Observation on Strategic Infrastructure Development Application
Ballyglass 10 year planning permission for a 110kV substation, underground grid
connection and associated infrastructure

ACP Case reference: VA03.324491

Applicant: Reeve Wave Ltd.

Image above is from the applicant's Phase 2 Construction & Environmental Management Plan, Figure 2.2. - Ballyglass Site Layout Map, showing Permitted Phase 1 (in grey) and (newly) Permitted Phase 2 Development (in blue).

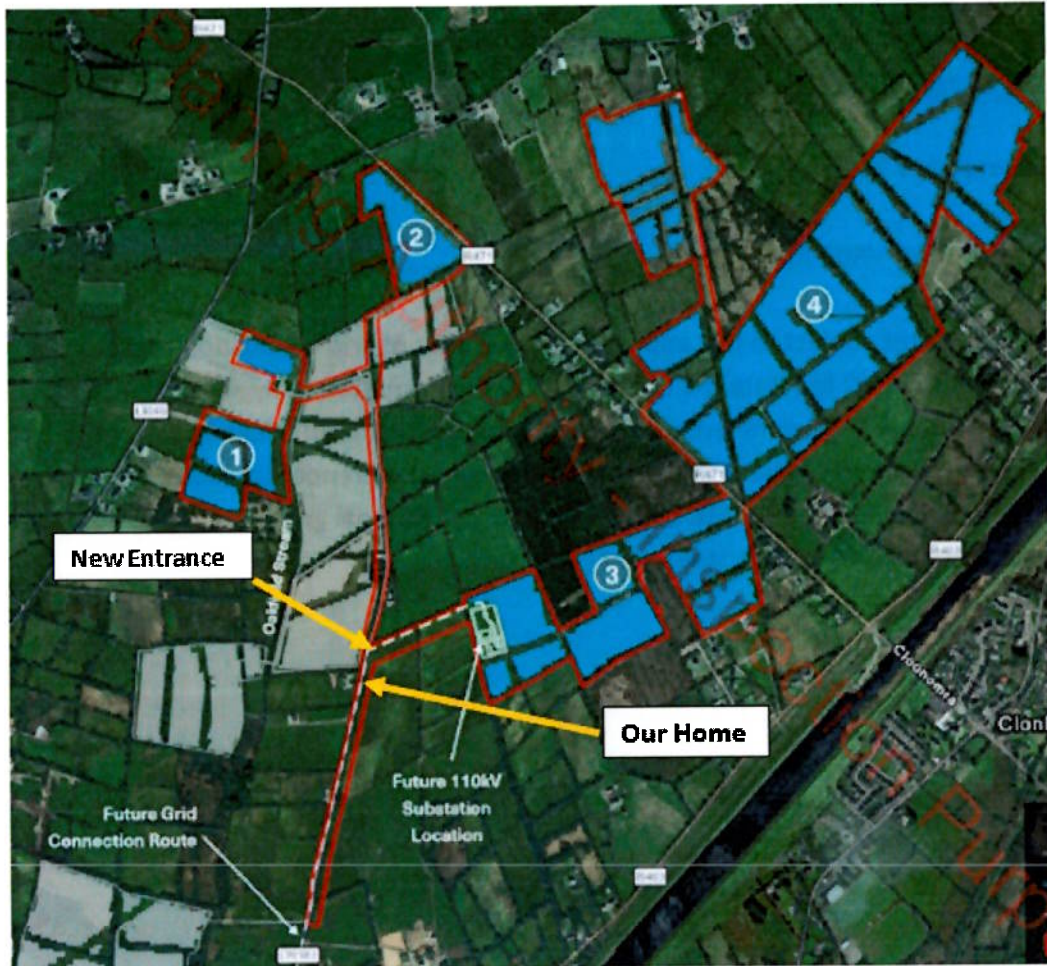
Our family are long term residents of Oakfield, Clonlara, on the L70382 road, Eircode V94X4H0; our home is referenced as **H020** on the applicant's **Ballyglass Solar Array - 24/06/2024 Map**. – as identified in the image below - approximately 80m from the 'New Entrance' to the proposed new substation development.

Image above showing the proximity of the proposed new "Entrance 1" approximately 80m from our home entrance.
